RIVERSIDE

Architecture Plan Changes Since December 2019 Submission

March 25, 2020

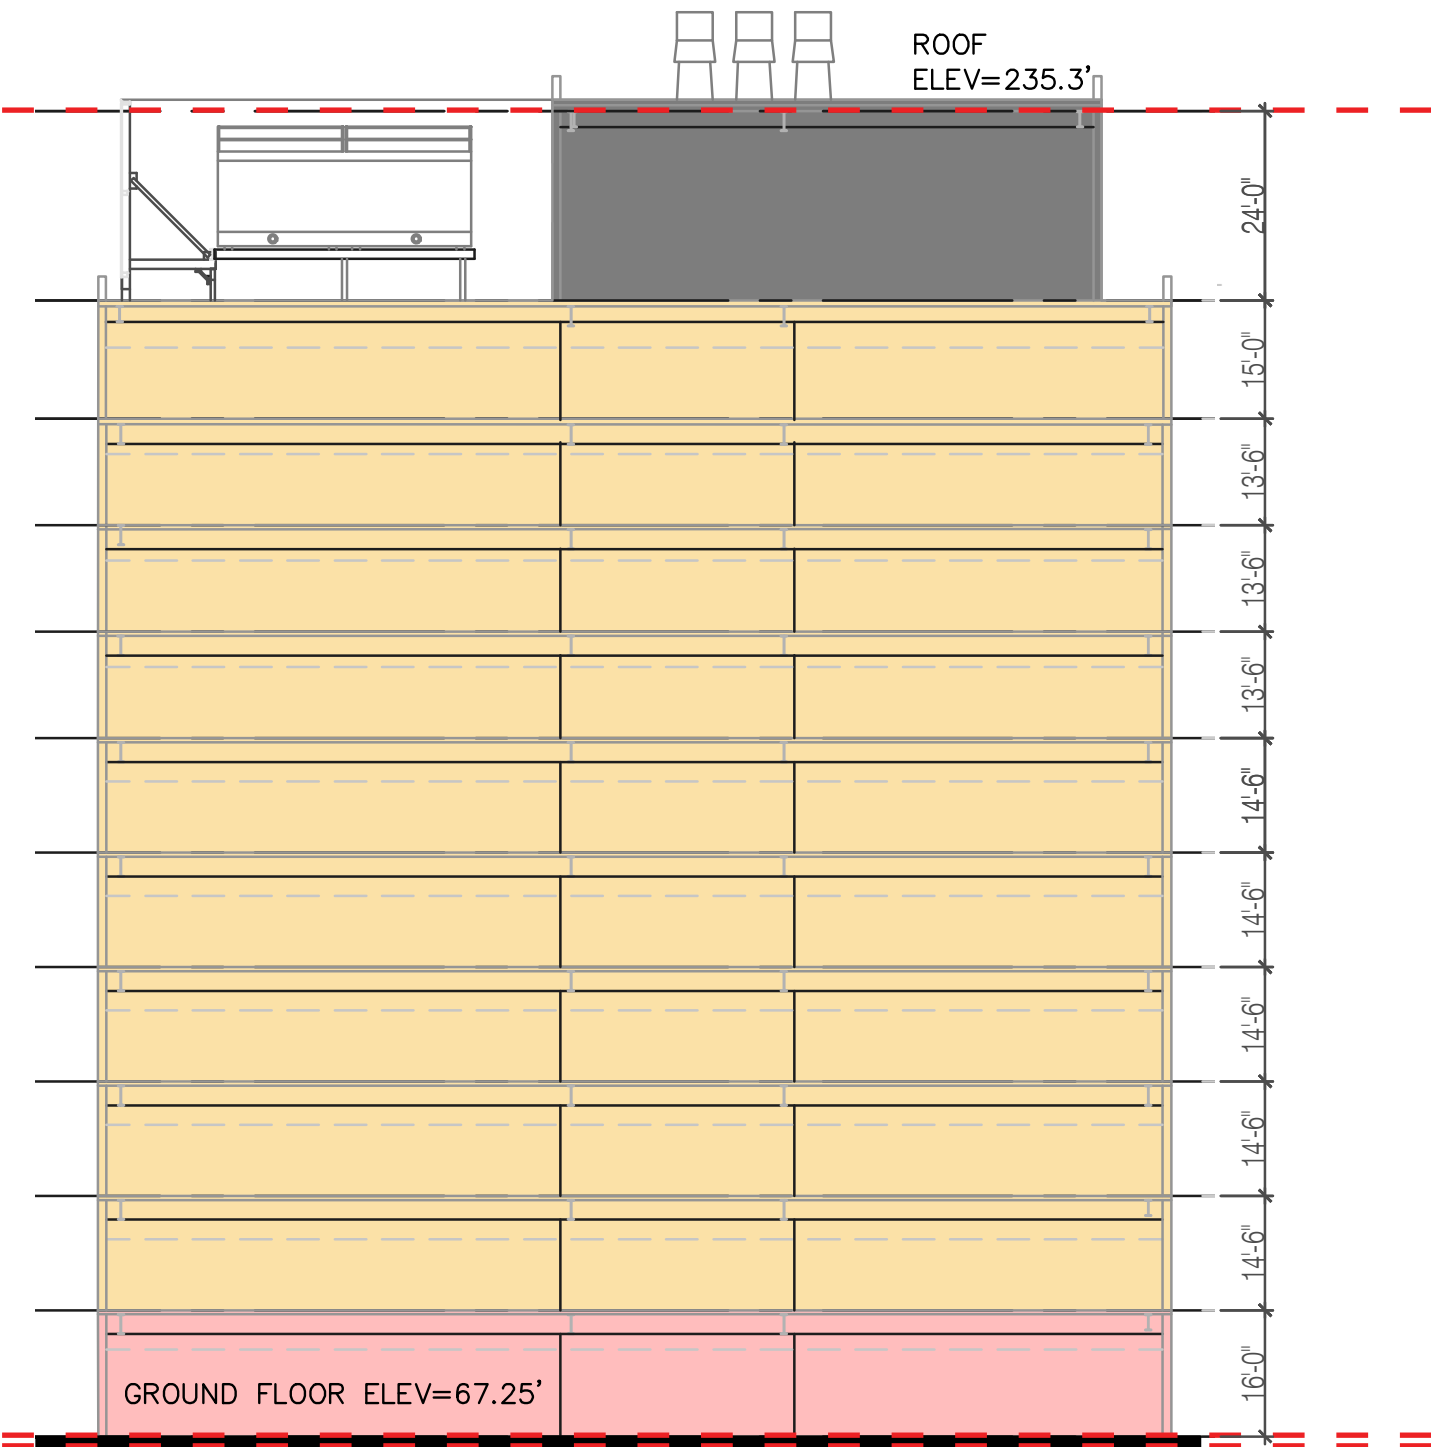
- Building 1
 - The Office Building Gross Floor Area (GFA) increased approximately 2,940 SF.
 - The Building core been redesigned to allow flexibility for lab/life science.
 - Level 1.5 (mezzanine level) was deleted.
 - Level 10 and Mechanical Penthouse footprints have been increased to match the floors below.
 - The Floor-to-floor heights below Level 10 changed; Level 10 and above heights remain unchanged.
 - Overall height of Building 1 has not increased and remains under 170FT.
